# **ADDENDUM NO. 1**

**City of Dublin City Hall  
Lobby Interior Renovation**  
5200 Emerald Parkway  
Dublin, OHIO 43017

Date: **April 12, 2013**

**Addendum No. 1** to the Drawings and Project Manual, dated **March 27, 2013**, for **City of Dublin, City Hall Lobby Interior Renovation**, 5200 Emerald Parkway  
Dublin, OHIO 43017; as prepared by Moody Nolan, Inc., 300 Spruce St. Suite 300,  
Columbus, OH 43215.

Dwg. Coord.: Tech. Coord.: M/N # 12340  
**ELECTRICAL NEW WORK PLANS**  
 BID / PERMIT SET  
**E2.0**  
 3-27-2013

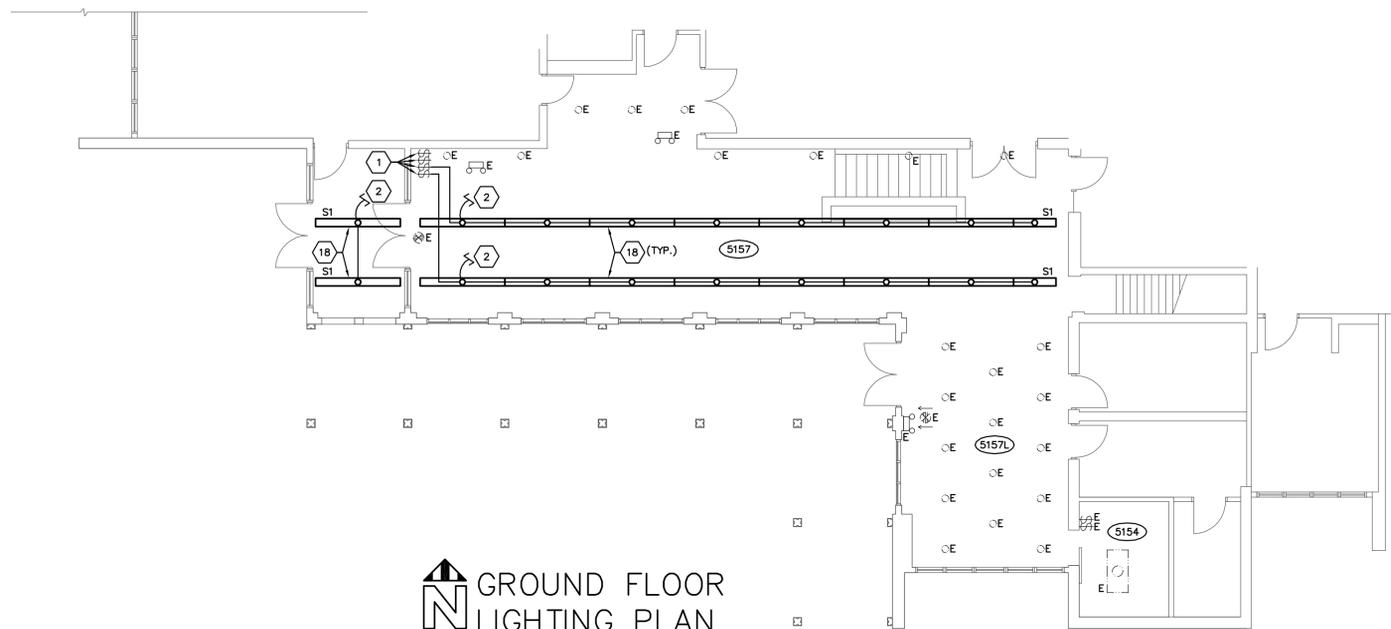
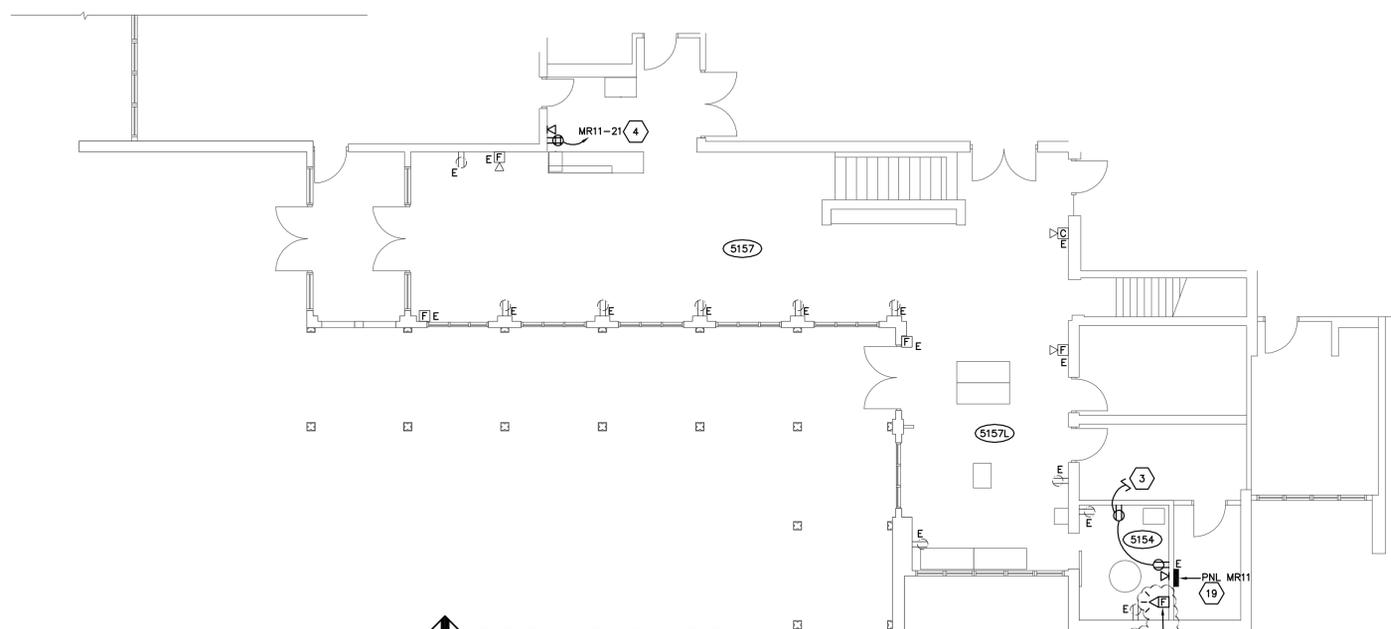
**Question:** On Sheet E2.0 Note 14 it calls for us to add (1) new fire alarm device. Are we required to have stamped drawings for this device? What are your requirements for adding this device if any?

**Answer:** *The E.C. is required to pay the owner's fire alarm contractor for all fire alarm work (per General note D on Sheet E2.0). This will include all permit fees and stamped drawings. (See Specifications Section A – GENERAL, paragraph 8 on Sheet E3.0). I think the plans examiner will want to see stamped fire alarm drawings.*
